Riverside Energy Park

Statement of Common Ground: Environment Agency (Signed)

8.01.11

Statement of Common Ground between the Applicant and The Environment Agency

Drawing Title:
Flood Defence Layout
Existing Wall Types – Layout
INDICATIVE POSSIBLE OPTIONS

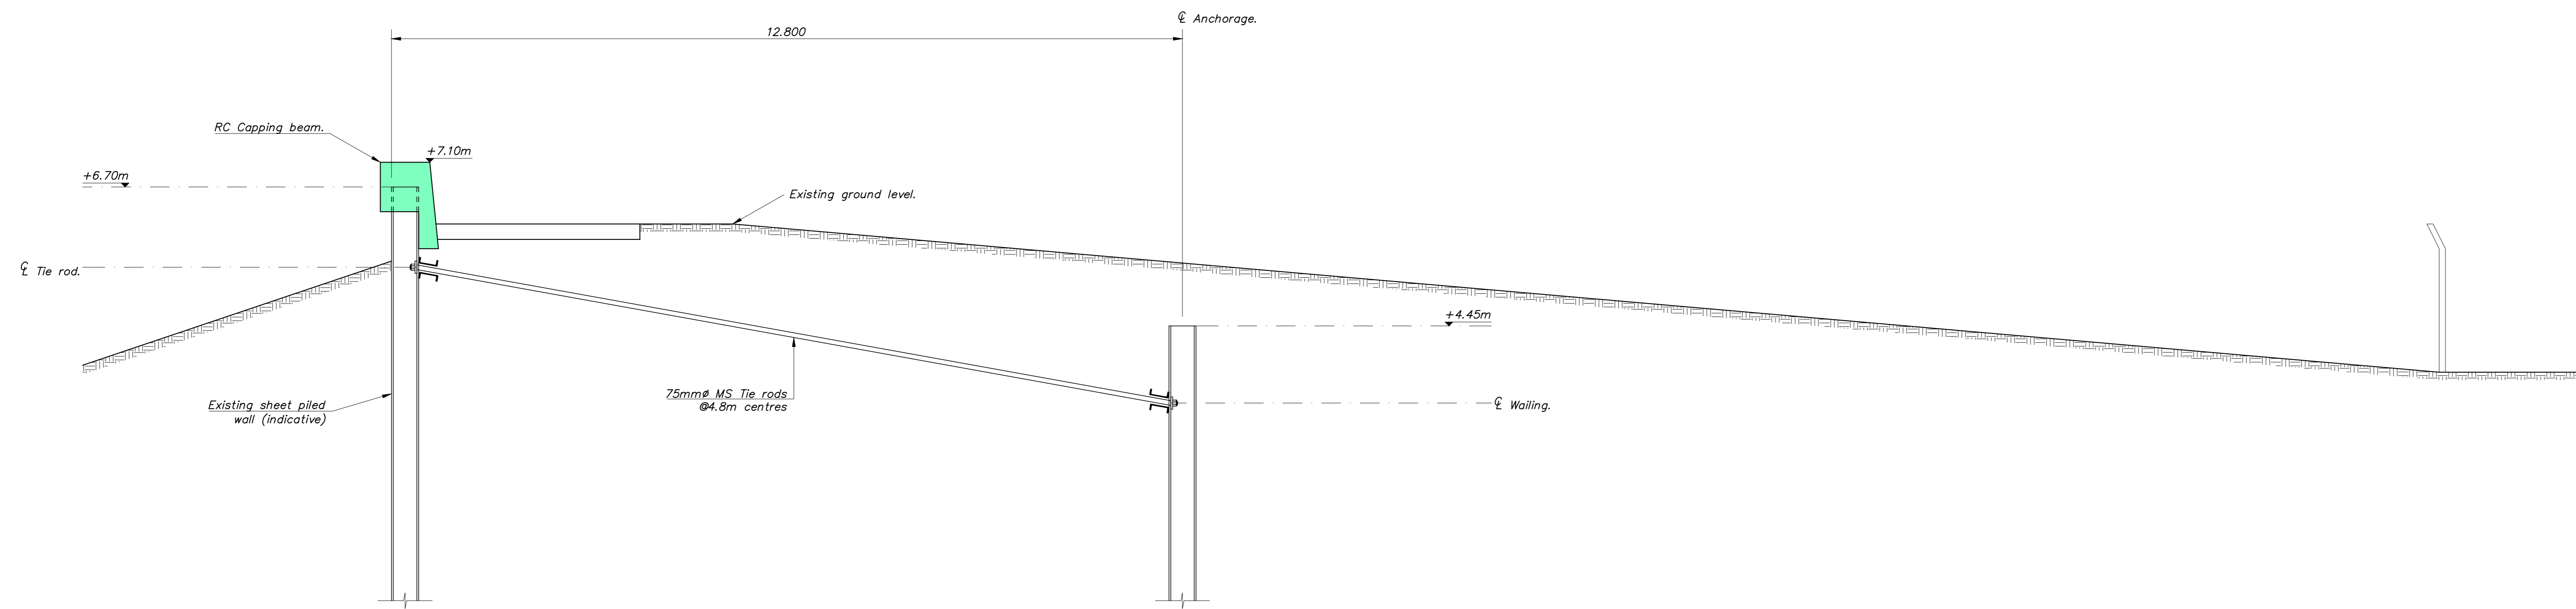
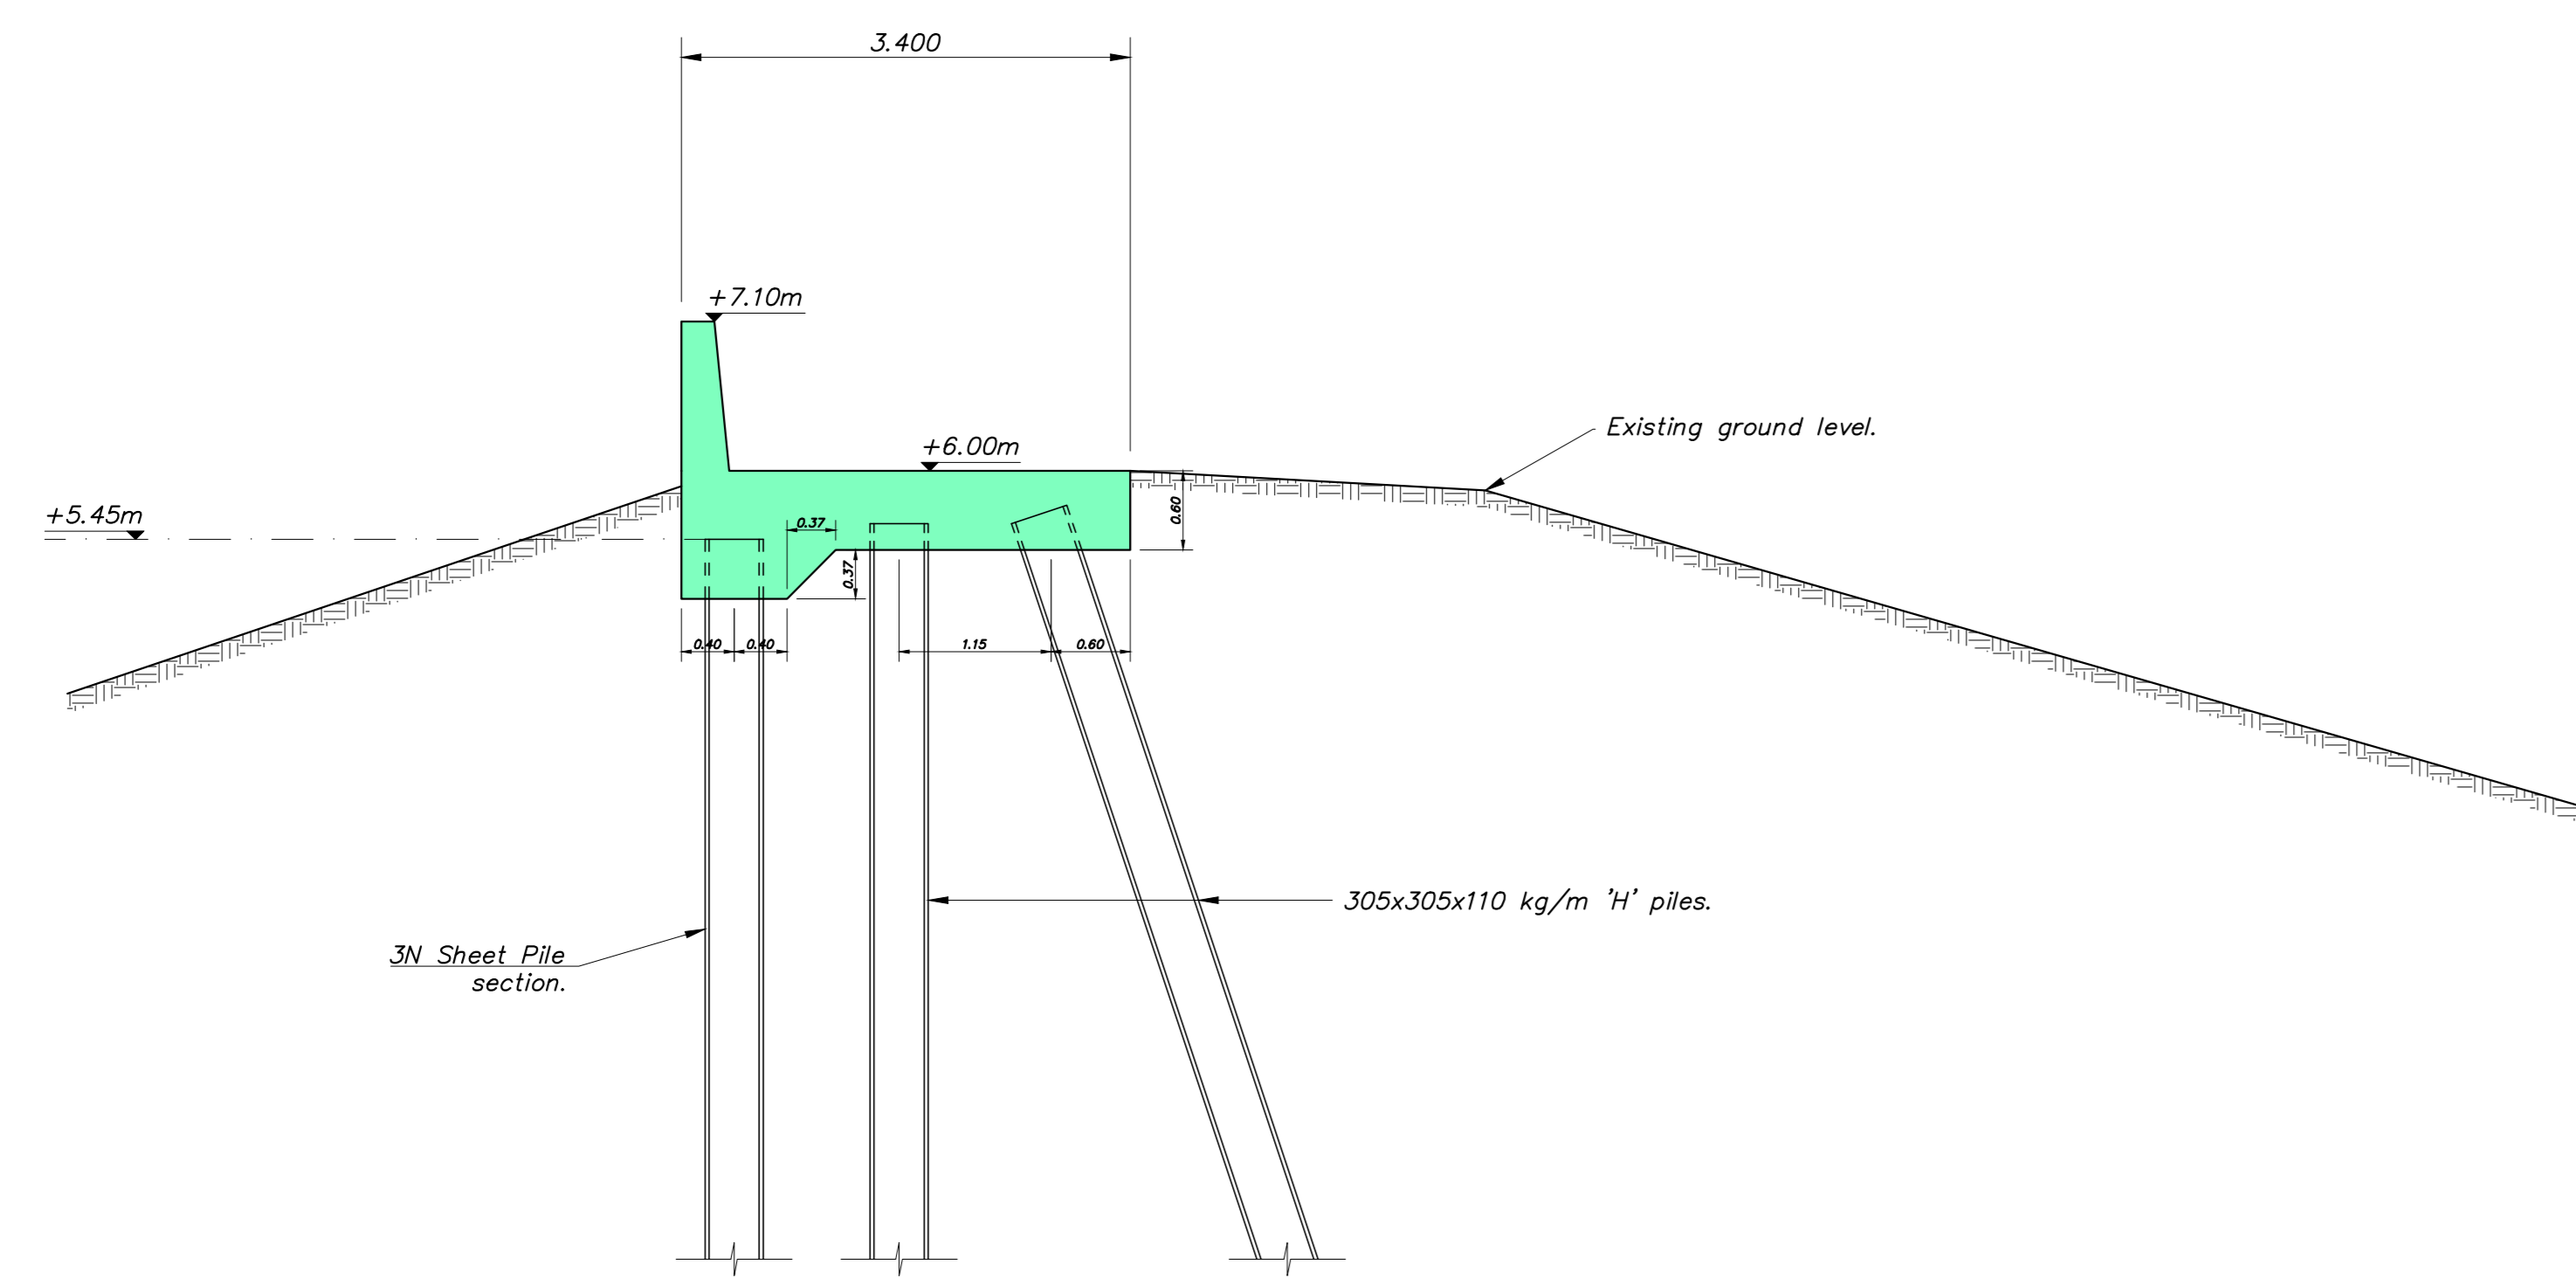
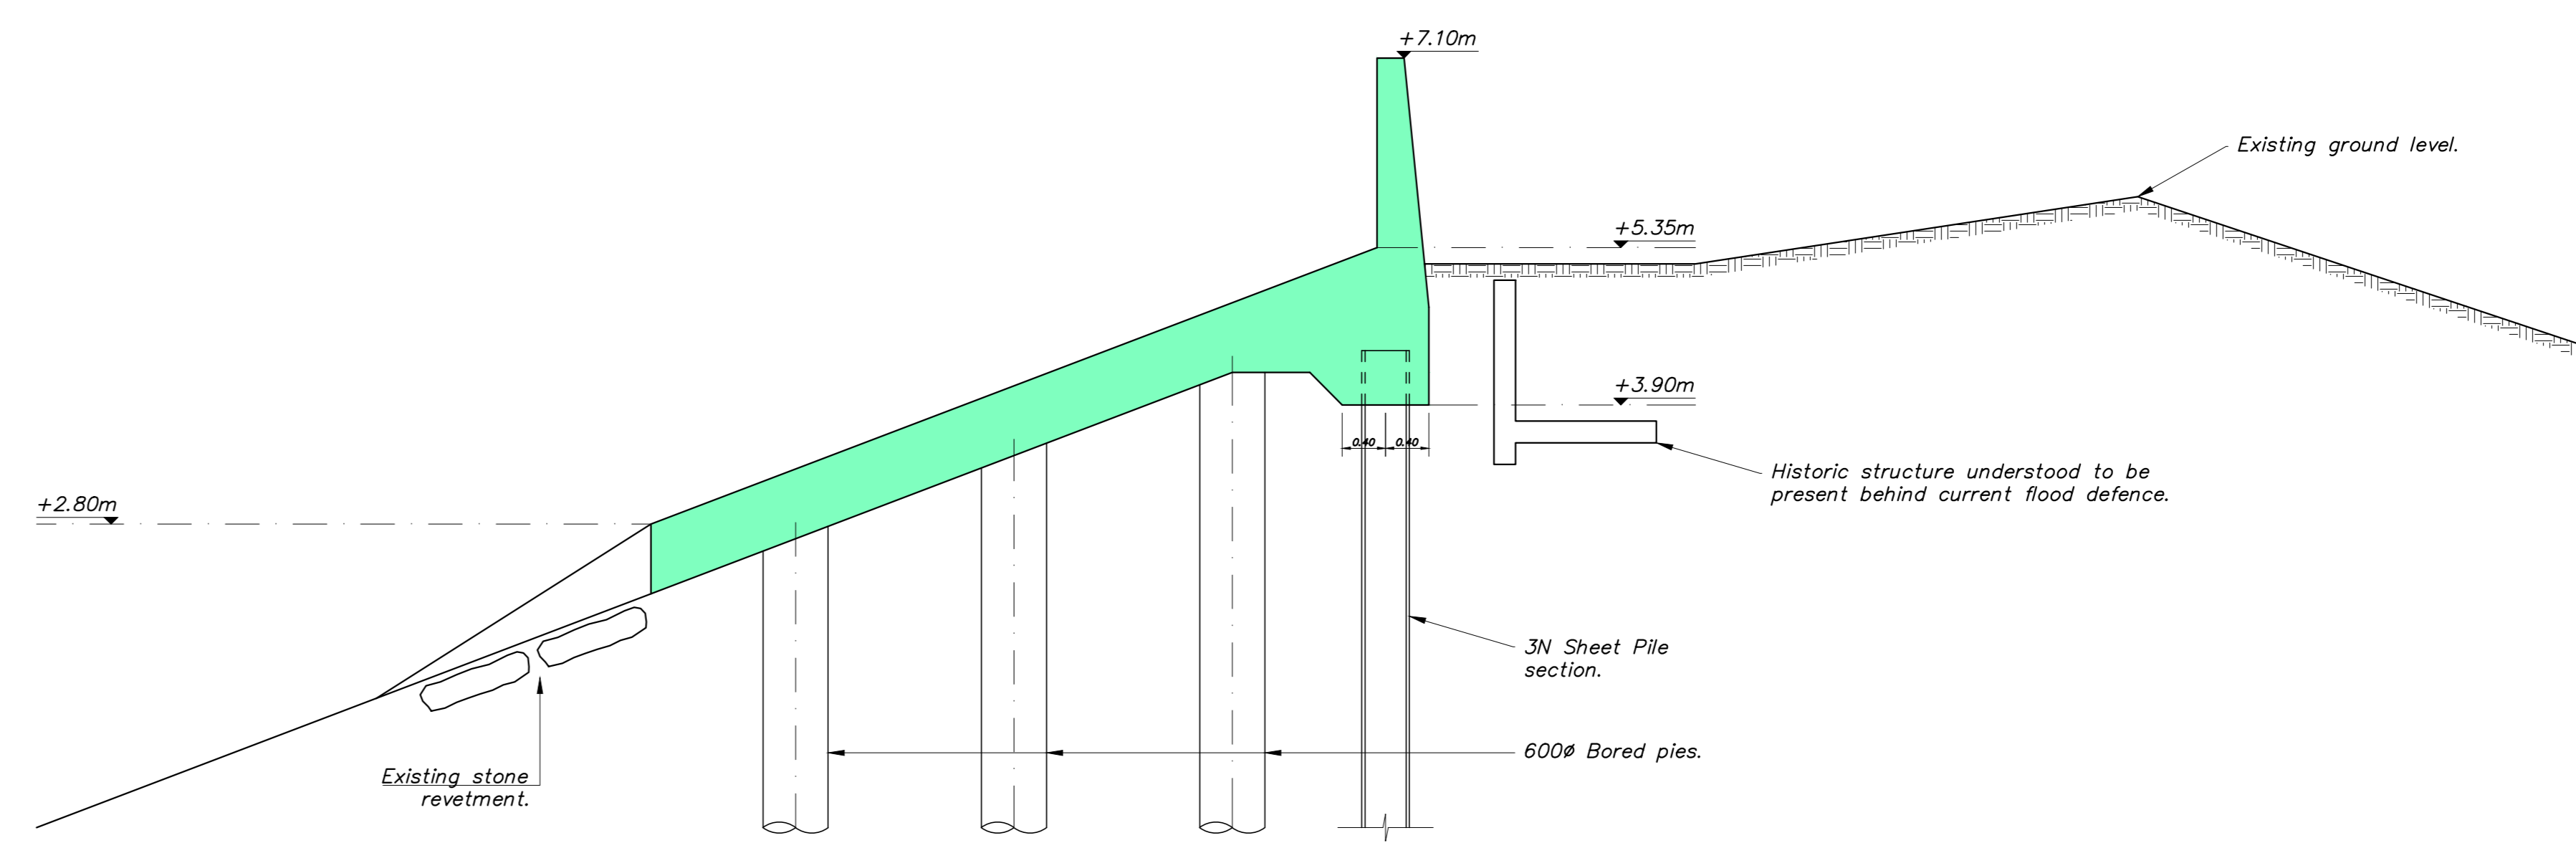
2.2.1 Through the indicative diagrams C110-113 (see **Appendix A** of this SOCG), the Parties agree that it has been demonstrated that the Proposed Development does not preclude the raising of the flood defence to the second stage level (of 7.7m AOD expected in 2070) proposed in the Thames Estuary 2100 Plan, and does not significantly restrict future defence raising options. These illustrative drawings were provided at the request of the EA in order to provide examples of technical solutions that could be adopted in the future should the need ever arise to raise the flood bank in line with the requirements of the Thames Estuary 2100 Plan.
